MFN 09-671  
October 27, 2009

Subject: Issues for Consideration, of RIN 3150-AH42, [NRC-2008-0332], Performance-Based Emergency Core Cooling System Acceptance Criteria

Issues for Consideration, RIN 3150-AH42,  
Performance-Based ECCS Acceptance Criteria

Figure 1

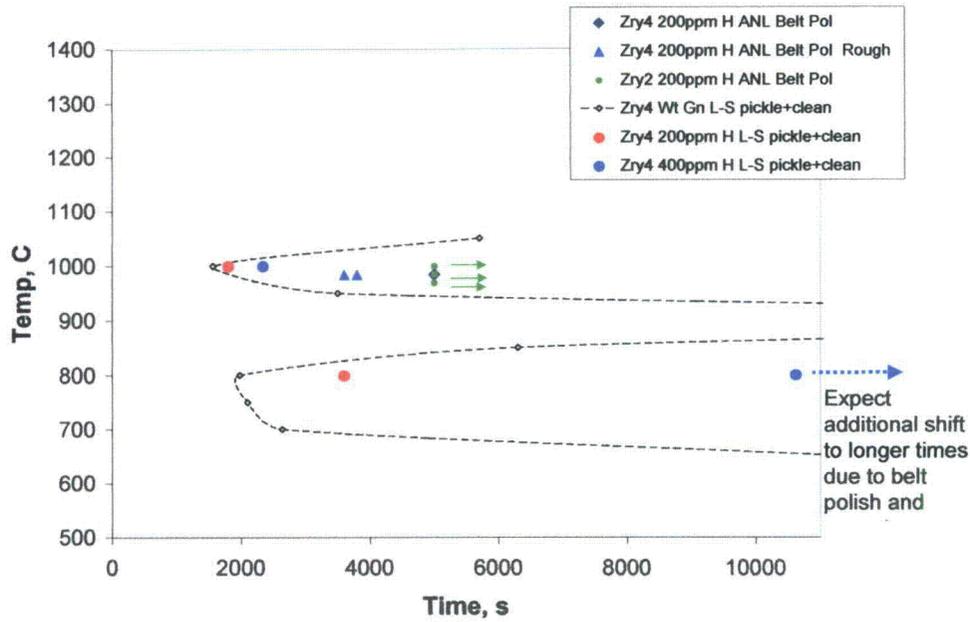
Zircalloys are susceptible to early onset of breakaway oxidation at two temperature ranges, one near 1000°C and the other near 800°C. The tests conducted at ANL focused on temperature near 1000°C. With respect to criterion for breakaway oxidation, Figure 1 shows data reported by Leistikow and Schanz (L-S) [Nucl. Eng. Des. 103 (1987) 65] based on either accelerated weight gain or when a hydrogen pickup of 200 ppm or 400 ppm is reached. In the ANPR, a criterion of 200 ppm hydrogen is proposed. The choice of the 200 ppm hydrogen is conservative relative the hydrogen concentration when cladding embrittlement occurs. Figure 63 of NUREG/CR-6967 shows that the embrittling concentration is closer to 600 ppm, which would take longer to reach than criteria based on 200 or 400 ppm of hydrogen. For breakaway oxidation near 1000°C, the choice of criteria (weight gain, 200 ppm or 400 ppm H) has little practical consequences and the L-S data indicated a range between ~1600 – 2300 seconds. The same is not true for breakaway oxidation near 800°C. The L-S data indicate that times to breakaway oxidation are ~2000 s, ~3600 s and ~10,500 based on, respectively, weight gain, 200 ppm H and 400 ppm hydrogen. Thus while accelerated oxidation began at ~2000 seconds, embrittlement due to hydrogen (~600 ppm) would not occur until after significantly longer than 10,500 seconds (for 400 ppm H).

With respect to surface condition, the ANL results and L-S data show that the breakaway oxidation time near 1000°C increased (from ~1600 to ~3600 s) when the surface condition was changed from pickled/clean (L-S) to belt polished (HBR rough surface). There is further increase (to >5000 s) when the surface finish is further smoothed (Belt Pol). The second figure shows the ANL and the L-S data together with data reported by Baek [J. Nucl. Mat. 335 (2004) 443] and Nagase [J. Nucl. Sci. and Tech. 40-4 (2003) 213] for Zircaloy-4 cladding in the pickled/clean state and polished states, respectively. The L-S, Baek and Nagase data show that for the breakaway oxidation phenomenon near 800 °C, there is a substantial increase in time to breakaway depending on the surface condition of

the test sample. The breakaway time increased from ~2000 s for pickled/clean state (L-S and Back) to ~7000 s for belt polished finish (Nagase) as measured by the weight gain method.

In summary, the time to breakaway oxidation at near 800°C would be greater than 10,000 sec for cladding in the pickled/clean state if a 400 ppm H criterion were used; at this hydrogen level the cladding is expected to be ductile. Further increase in time to breakaway oxidation near 800°C would be expected for modern cladding in the belt polished condition. Since the time to breakaway oxidation near 1000°C is ~5000 s or less for cladding in the pickled/clean or rough polished state, the susceptibility of Zr-alloys to embrittlement due to breakaway oxidation is relevant in the temperature range near 1000°C but not near 800°C. GEH/GNF believes that the threshold temperature could be set at 1650°F (899°C) without compromising safety concern due to breakaway oxidation.
